Memorandum

RE: Other Business for the December 10, 2020 Planning Commission Meeting

This memo is to provide background for the Planning Commission to consider as a part of the Other Business to be reviewed during the December 10, 2020 Planning Commission meeting.

DATE: 30 NOVEMBER 2020 SCALE: PROJECT NO. 12393.CF C3 OF 17

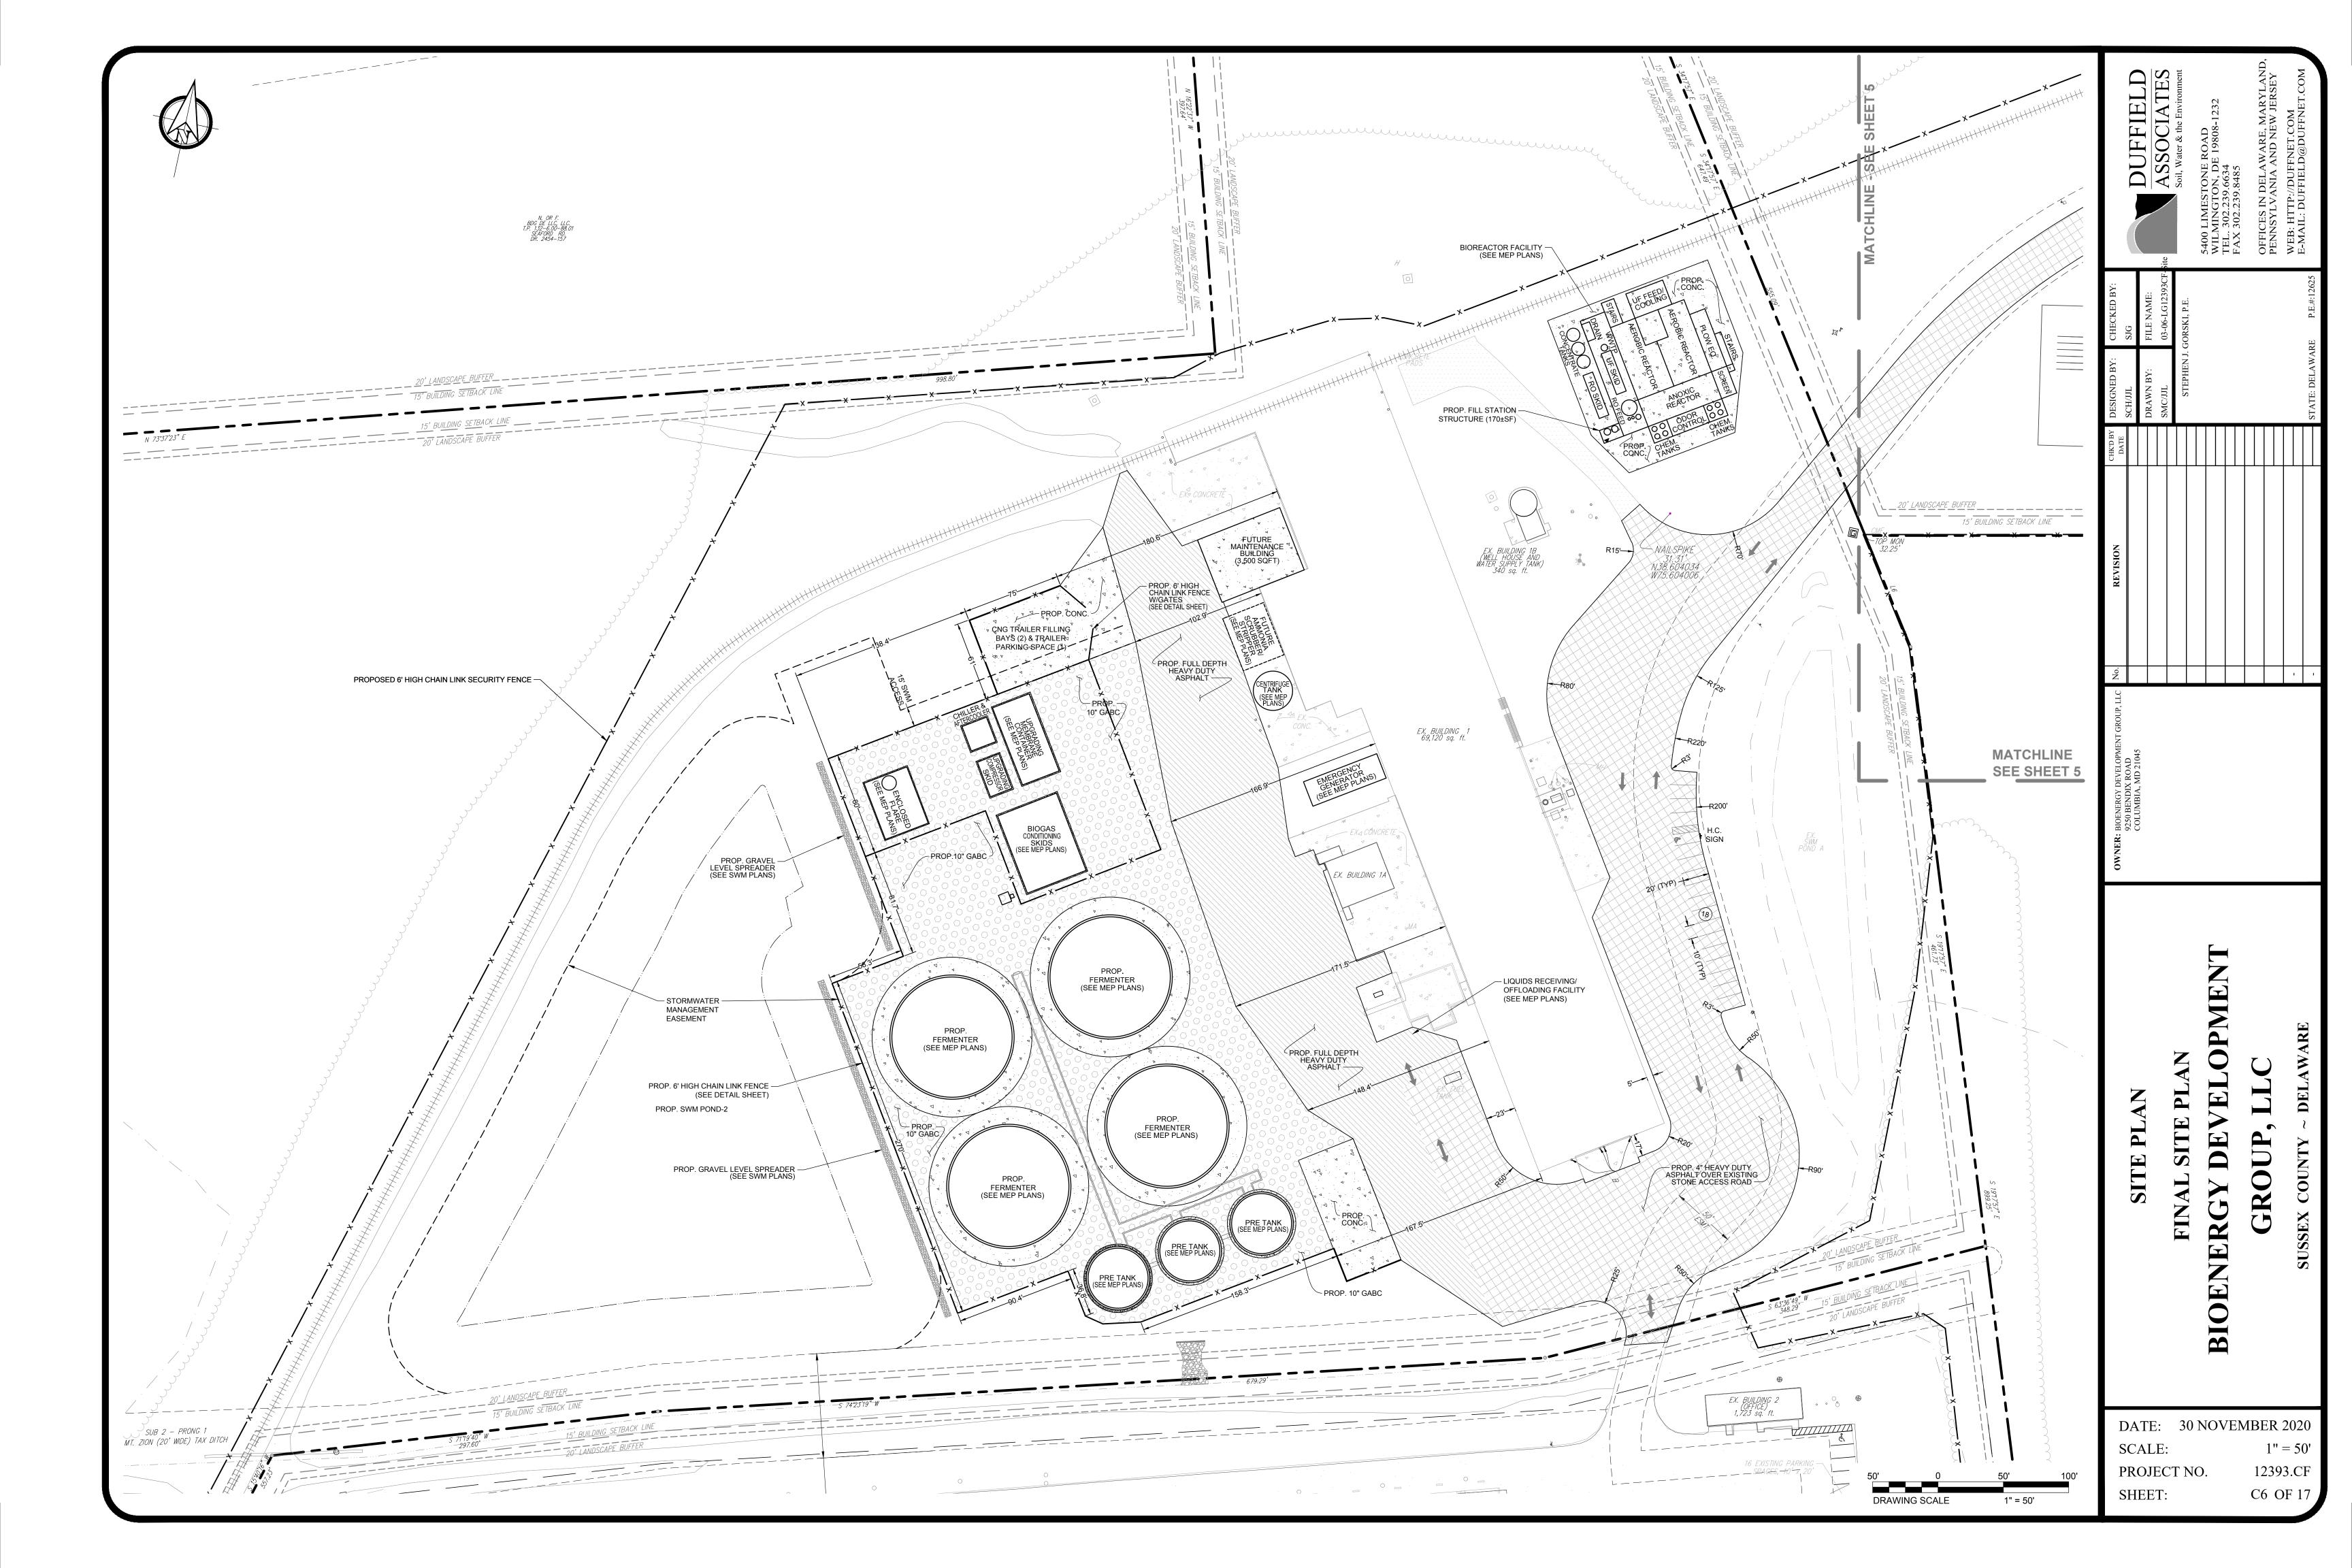
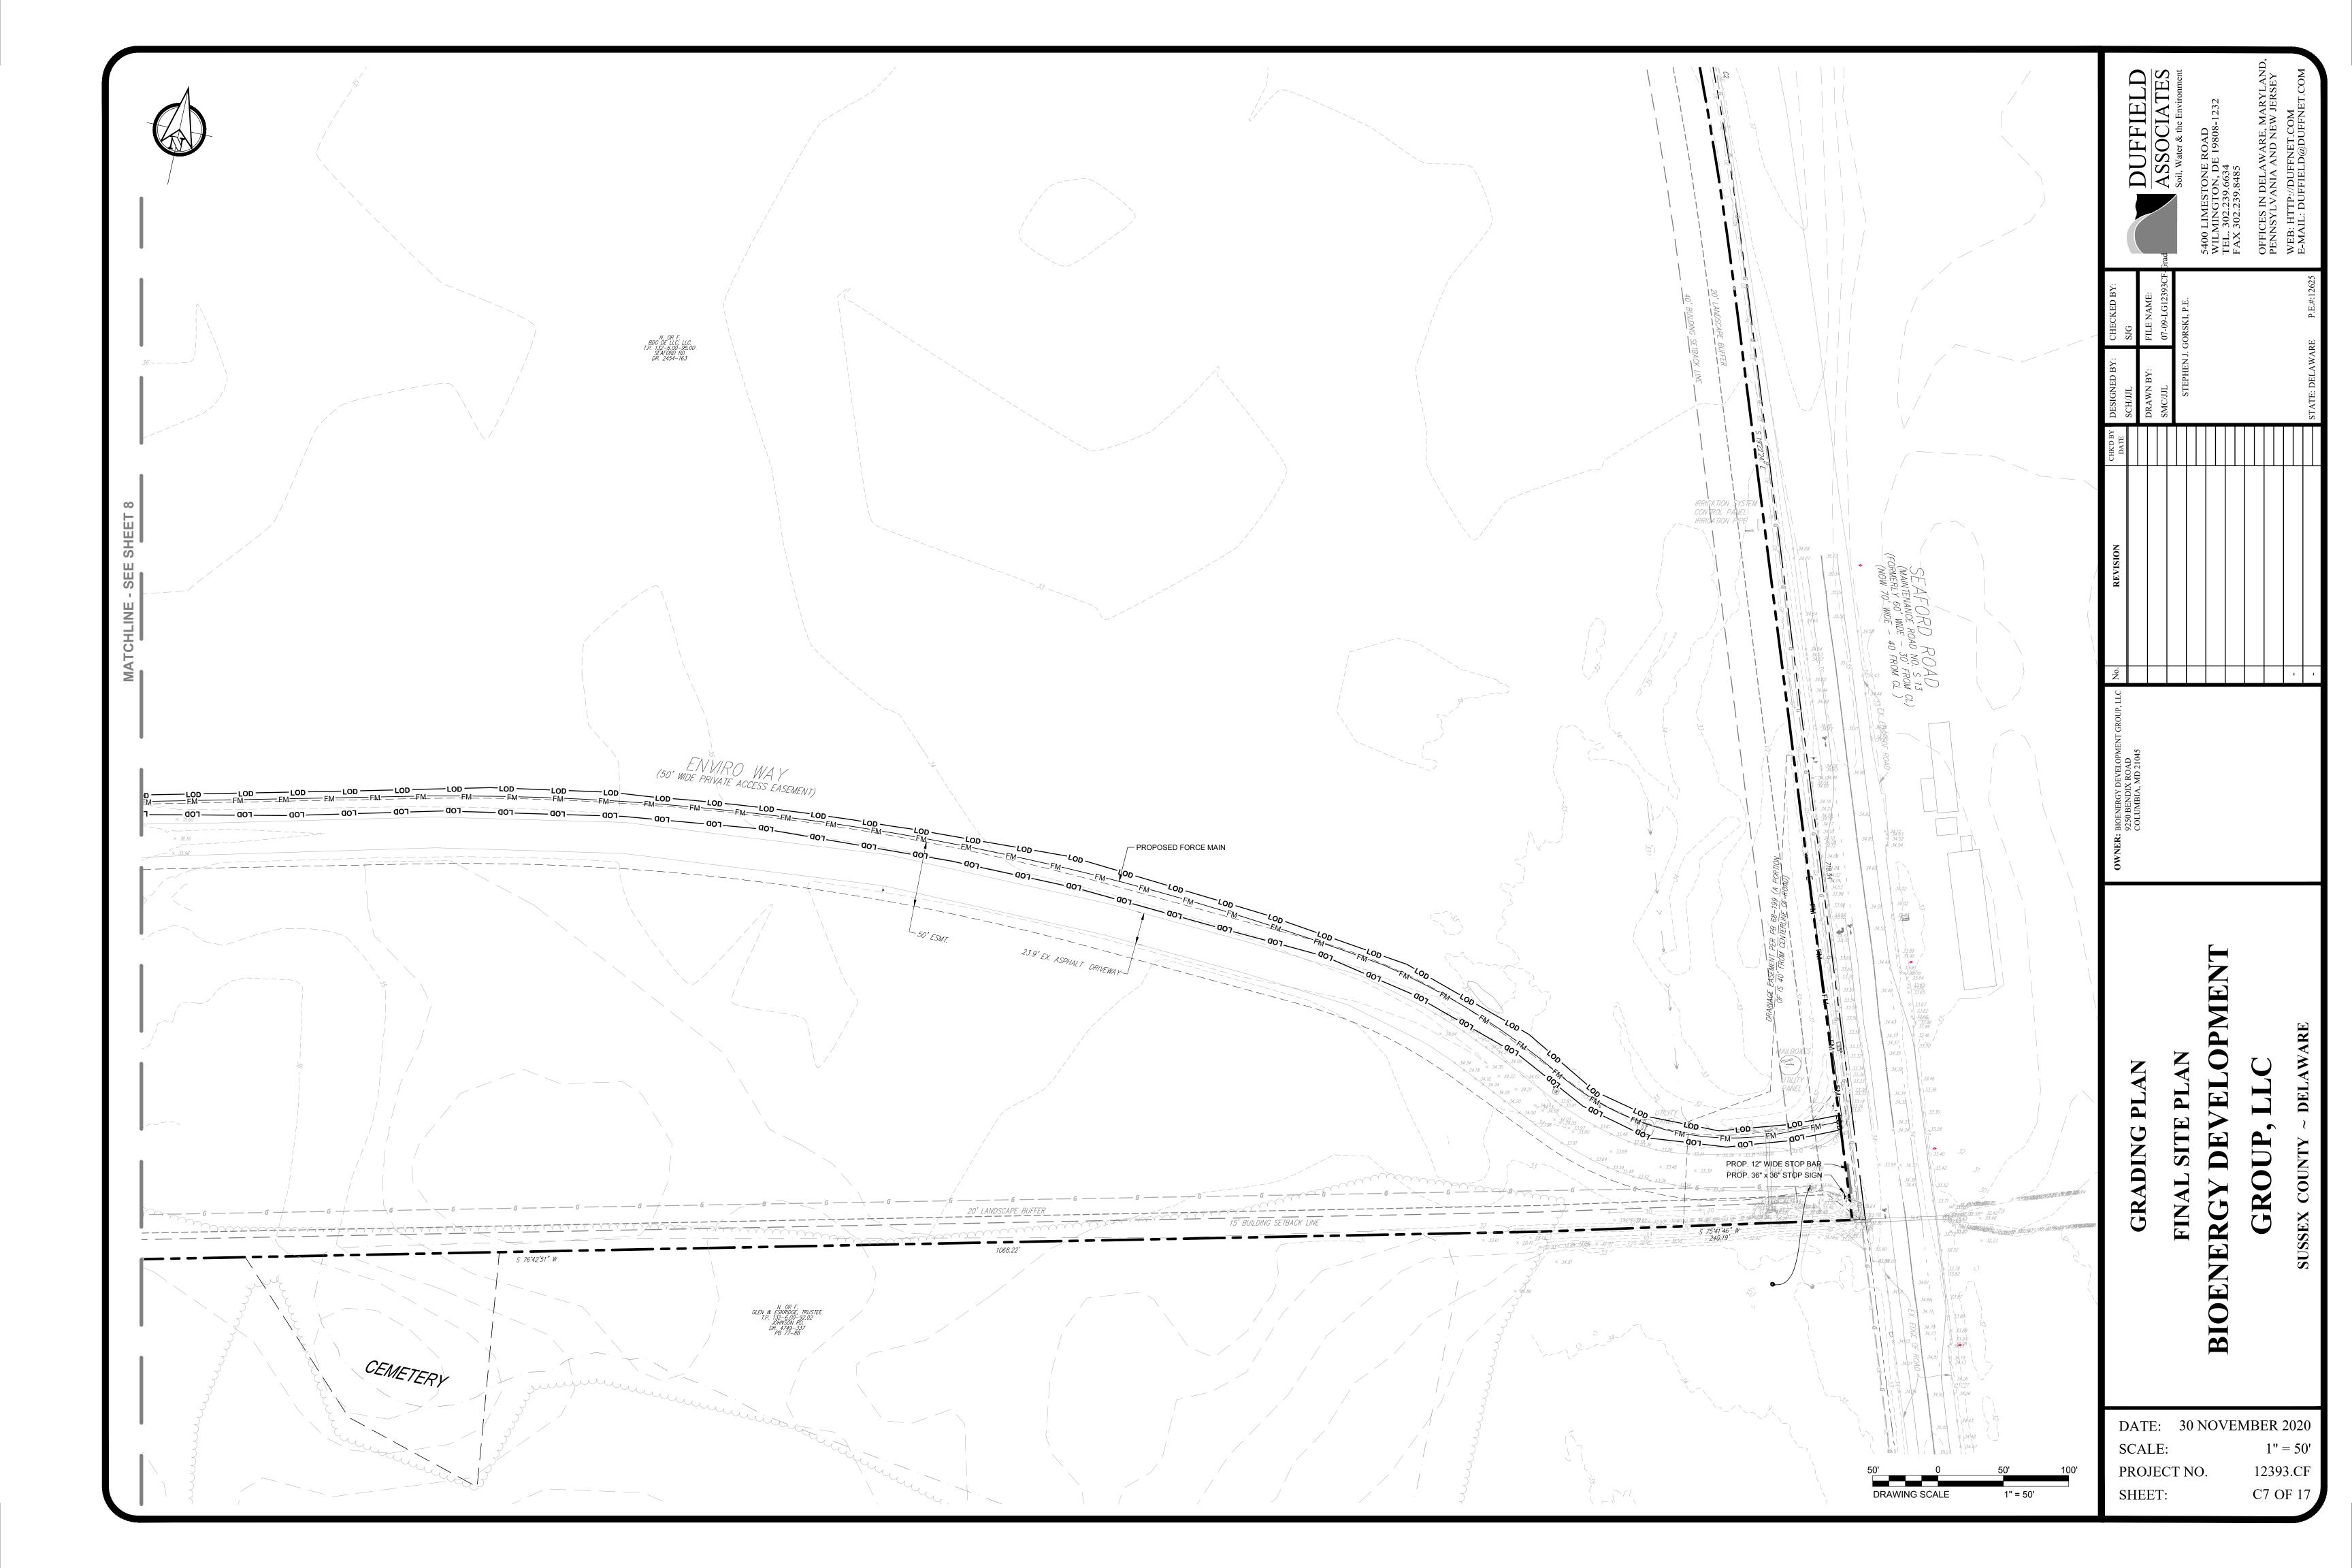
This is a Final Site Plan for the addition of seven (7) storage tanks and other associated works to be located in the already improved area located between Building 1 and Building 3. The site plan also shows a proposed 3,500 square foot maintenance building, along with new landscaping and fencing along Enviro Way. There are no proposed changes to the existing parking numbers and the plans propose the relocation of the scales near the entrance to the site. The parcel is located on Enviro Way, on the west side of Seaford Rd. (Rt. 13A). The use of this site as a composting facility as an addition/extension to the previously approved micro-nutrient plant for the processing and handling of poultry litter was approved by County Council on June 25, 2013 under Conditional Use No. 1962, and this change was adopted through Ordinance No. 2311. The Final Site Plan complies with the Sussex County Zoning Code and all Conditions of Approval. Further Final Site Plan approval will be required for any other future improvements. Tax Parcel: 132-11.00-41.00. Zoning: AR-1 (Agricultural Residential Zoning District). Staff are in receipt of all agency approvals.

The Delaware Department of Transportation (DelDOT) has reviewed your request, dated September 3, 2020, to obtain a Letter of No Contention (LONC) to use an existing commercial building and site entrance for the above referenced project. In coordination with the South District Public Works Office we have determined that your project will require some modifications or enhancements to meet current regulatory requirements. We have therefore determined that this project is eligible to obtain a Permit for Entrance Construction (PEC) to make these modifications. The PEC will include a list of items that must be addressed, as well as requirements for bonding to perform work, where needed, within the State of Delaware right-of-way (ROW). This approval shall be valid for a period of one (1) year.

- 1) Site shall have access from the existing entrance located on Seaford Road (SCR 013).
- 2) Only the modifications/construction or traffic pattern changes that are itemized and authorized under the PEC will be permitted. Please coordinate with the DelDOT Public Works Office regarding the scope, location and limits of the following items, as well any other items listed in the PEC:
 - a) Replace existing stop sign with a new 36"x36" R1-1 stop sign and install a new 16" wide thermo stop bar
- 3) DelDOT reserves the right to review, modify or revoke this authorization letter and PEC and require additional entrance upgrades in the future if proposed activities create traffic conflicts, safety concerns or operational issues.
